Design Advisory Board

Tuesday, August 27, 2024, 3:00 PM

MEMORANDUM

To: Design Advisory Board
From: Scott Gustin
Re: 251-253 South Union Street
Date: August 27, 2024

planting
plan
scale: 1/16"=1'-0"

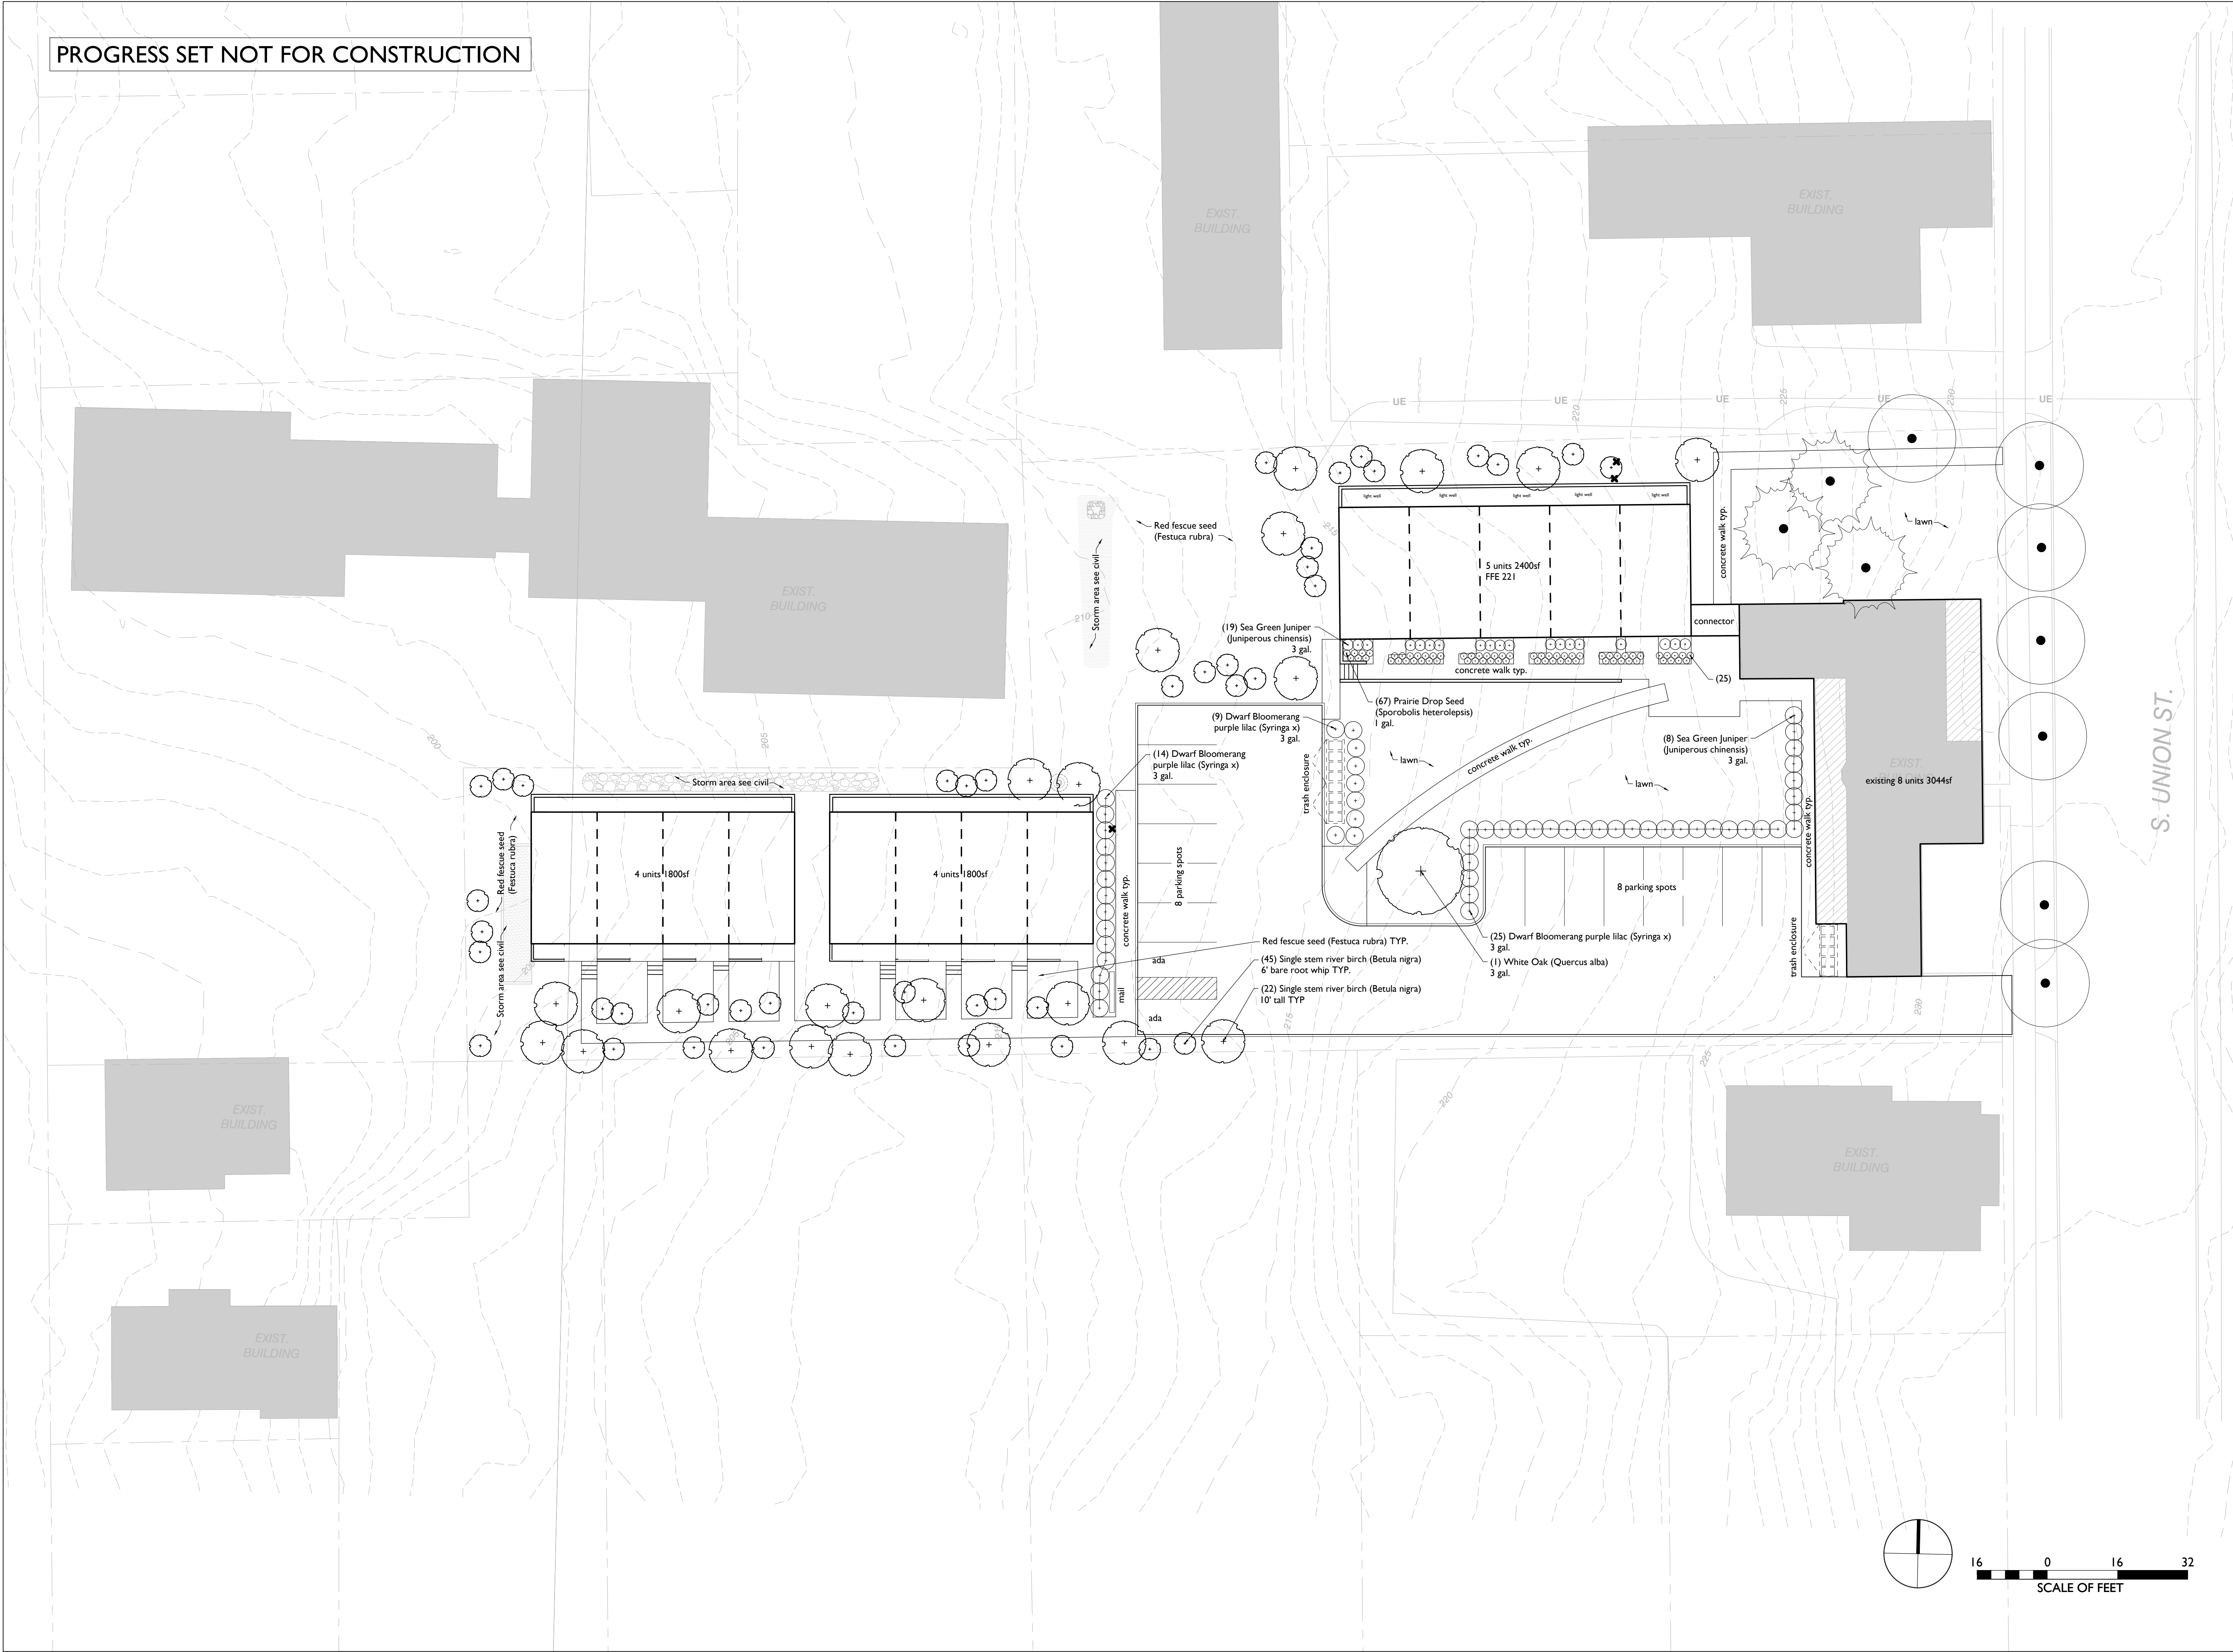
A landscaping plan is included and depicts species and location. New plantings are used to define borders and interior spaces and to provide screening as well. Proposed species appear to be acceptable and include no invasives. Shade trees are needed as noted above.
